PLANNING, ARCHITECTURE, ZONING BOARD

City of Avondale Estates
Planning Architectural Zoning Board
Staff Review, Variances *

Applicant: 278 Oak Holdings LLC: Jetha Wagner, Avila Development

Property Address: 136 Laredo Drive, 2968 Parry Street, 147 Oak Street, 2950 Franklin Street, and 2556 Franklin Street (Oak Parcel)

NEW STREET B

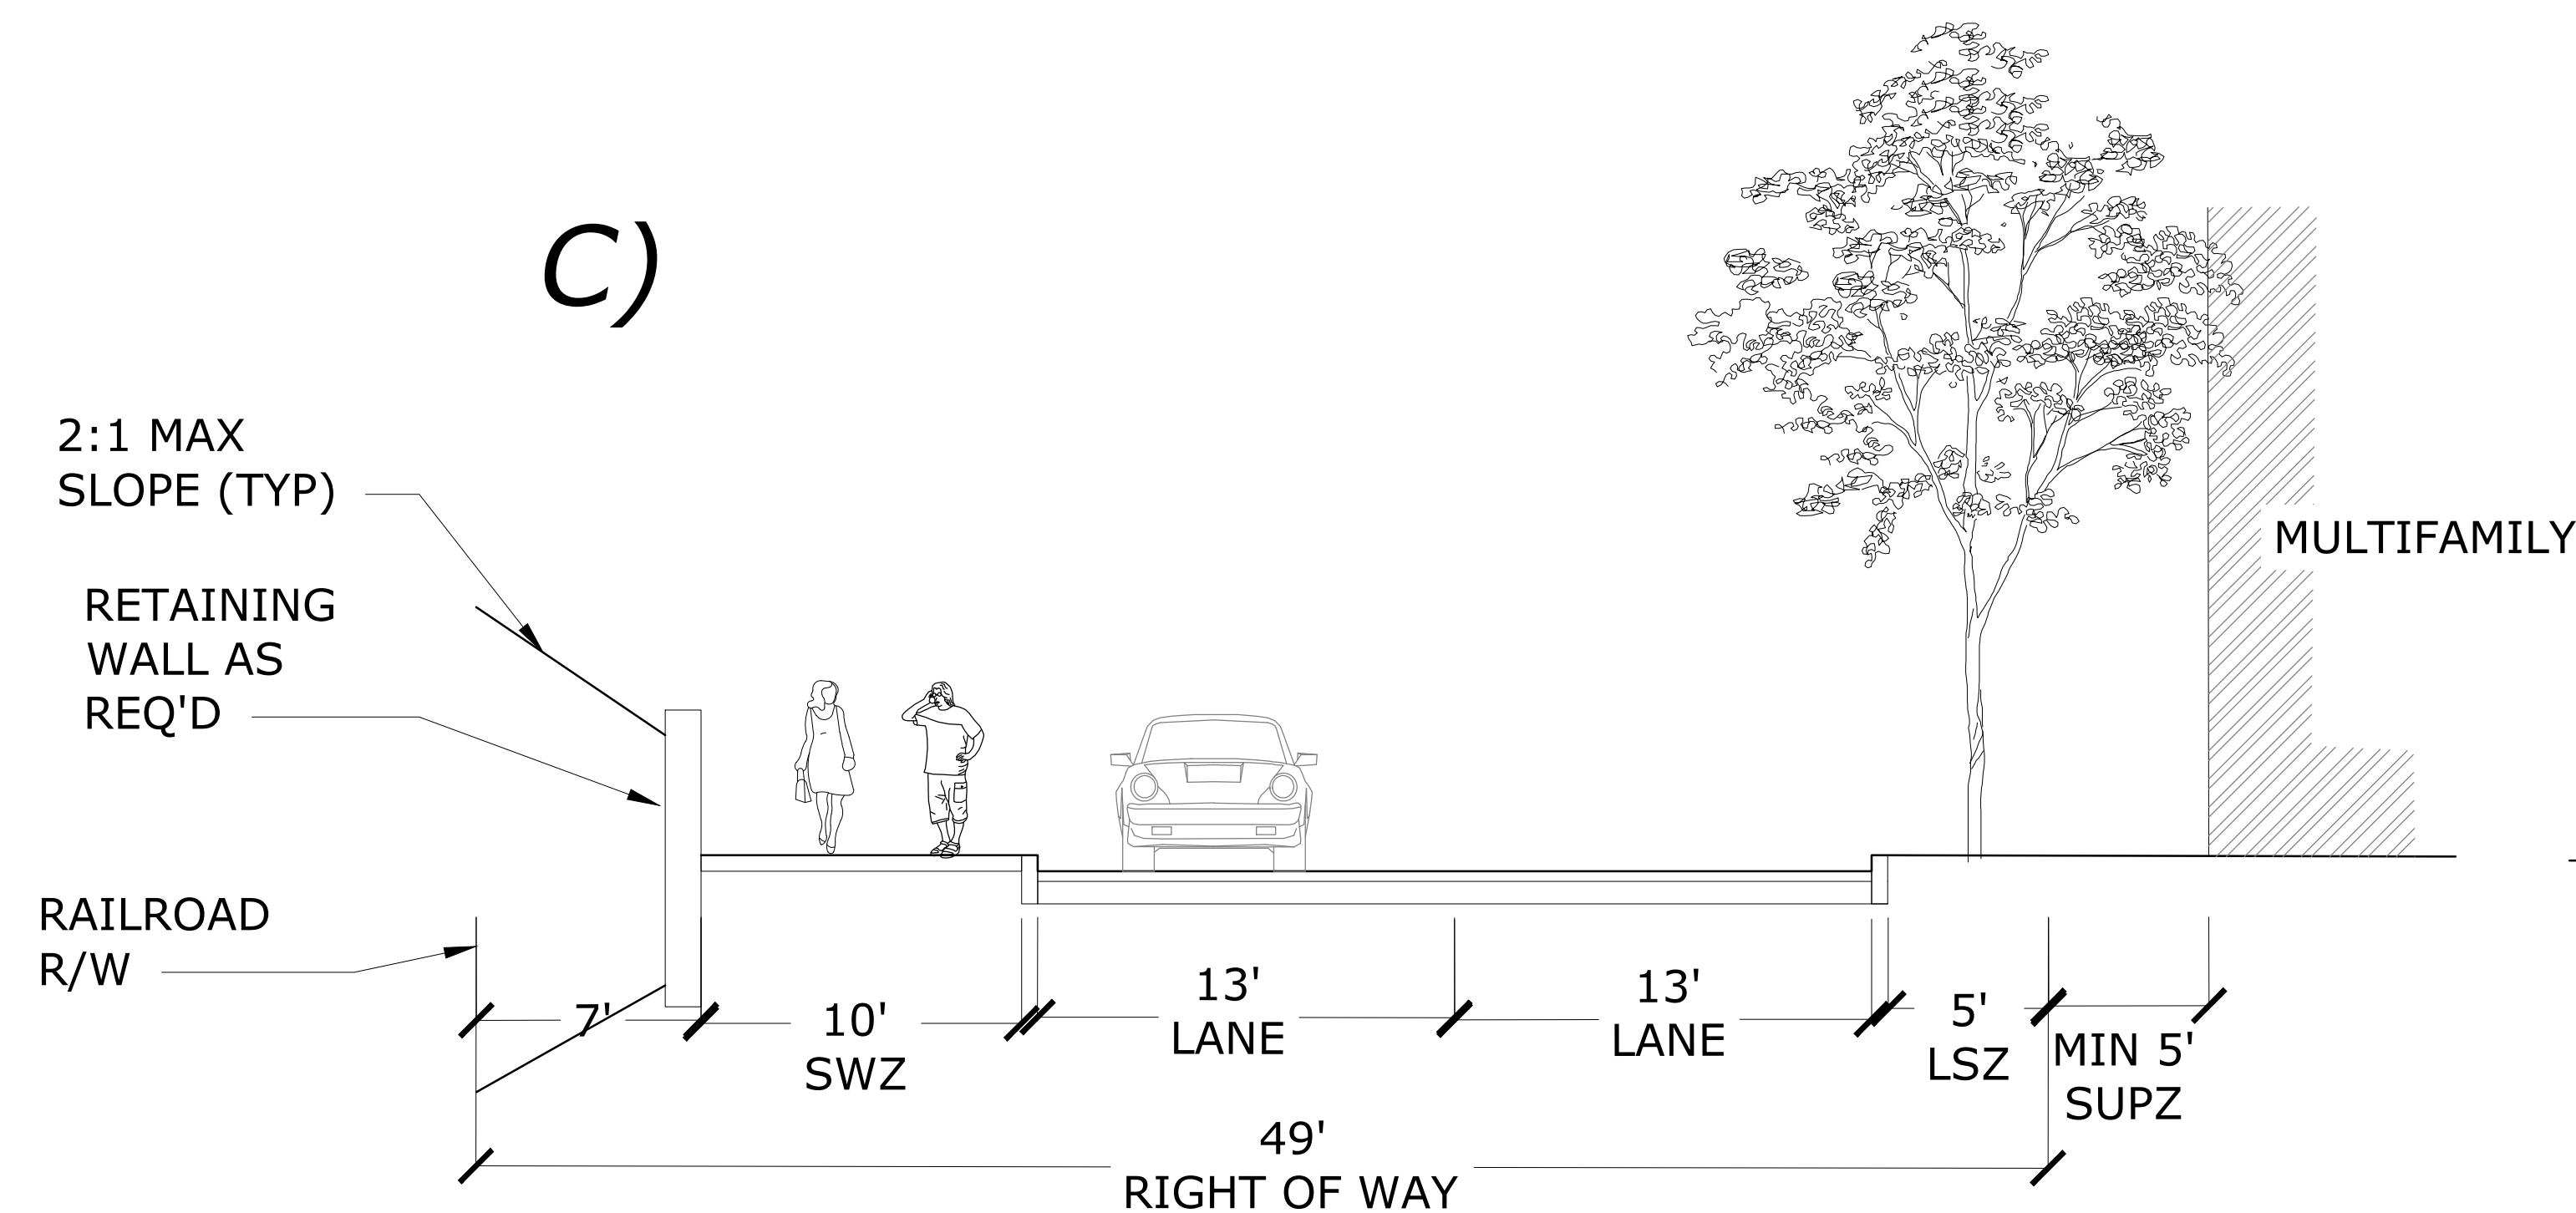
FROM: Figure 21-3.2.8.B.4.b and Table 3.2.8.E reduce type B3 street section from 45' ROW, 3 LSZ and 5' SUPZ to building face.

Figure 3.2.12.F - Transitional Height Plane

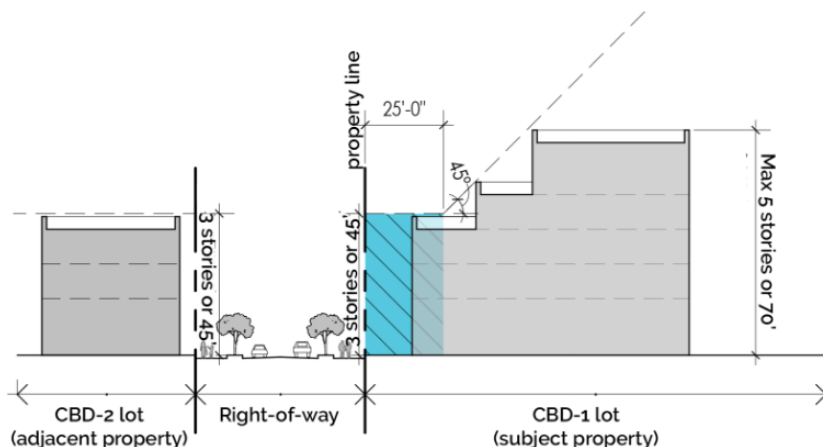
DESIGN TEAM NOTE: This requirement impacts the Southeastern corner of the Maple Street site, which abuts the CBD-2 district across Olive Street. This would limit that portion of the building to 3-stories (instead of 5) which could eventually step up to 5-stories. See Figure 3.2.12.F below. Need to be allowed 5-stories (plus basement) in all locations – including areas where transitional height plan comes into play.

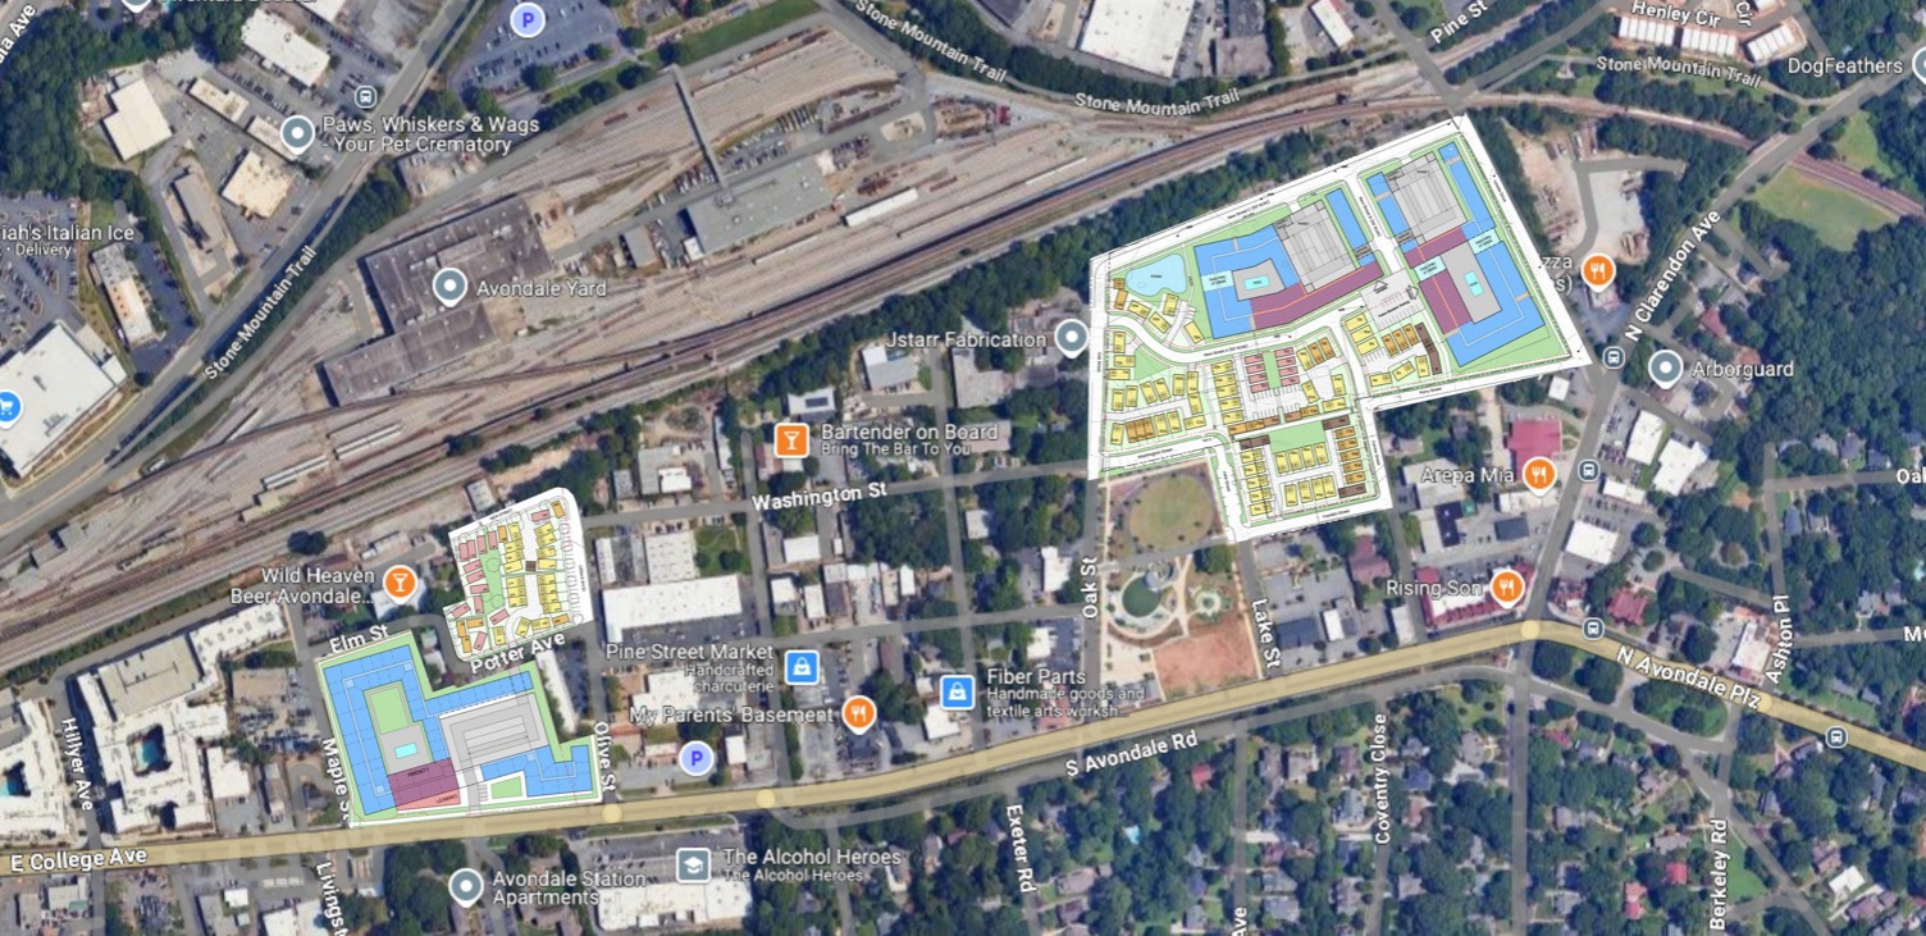
DESIGN TEAM NOTE: Based on this requirement, each MF building would be required to have 5-7 loading spaces. Need to reduce this down to 1 loading spaces per building.

Figure 3.2.12.F - Transitional Height Plane

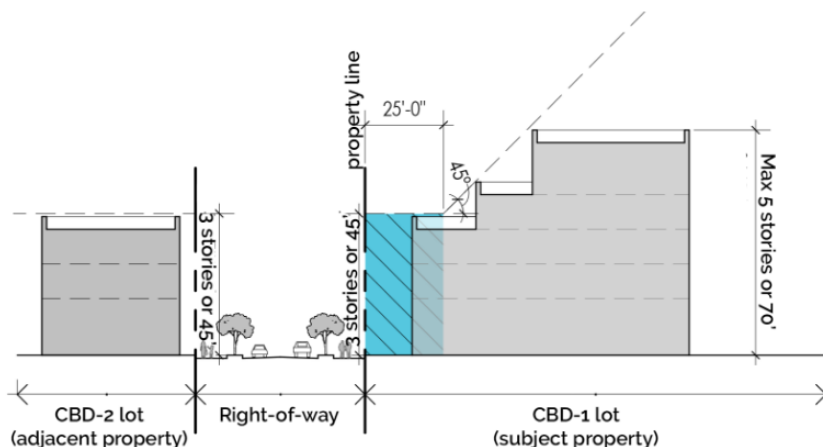
DESIGN TEAM NOTE: This requirement impacts the Southeastern corner of the Maple Street site, which abuts the CBD-2 district across Olive Street. This would limit that portion of the building to 3-stories (instead of 5) which could eventually step up to 5-stories. See Figure 3.2.12.F below. Need to be allowed 5-stories (plus basement) in all locations – including areas where transitional height plan comes into play.
